SUBMITTAL: 1400 SERIES AED CABINET

104313-001
CONTRACTOR / CM SUBMITTAL NO.

PROJECT: 15051-Webster University Interdisciplinary Science Building

RE: AED cabinet product data

3/8" Flat Trim | 1-1/2" or 1-1/4" Square Trim | 2-1/2", 3" Rolled Edge | 4" Rolled Edge with ADA Pull | Surface Mount Square Trim | Surface Mount Opt. Rolled Edge

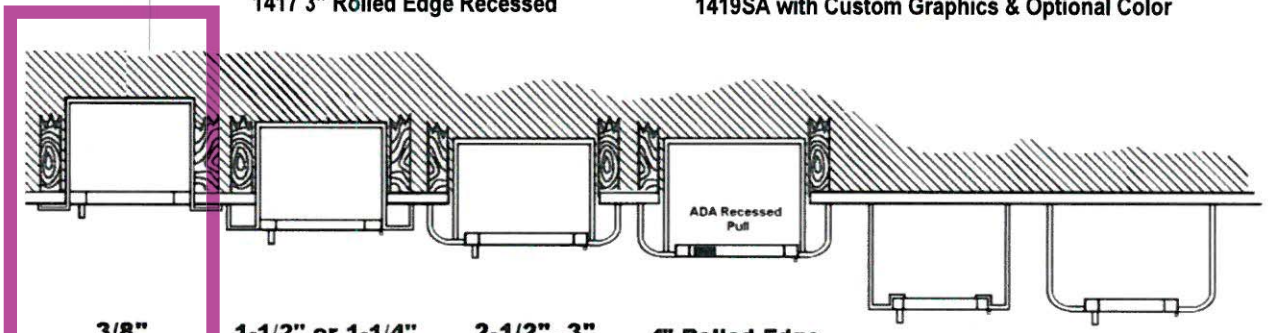
PROVIDE RECESSED - 3/8" FLAT TRIM STYLE TO MATCH WITH FIRE EXTINGUISHER CABINETS.

SEE MARKUPS.
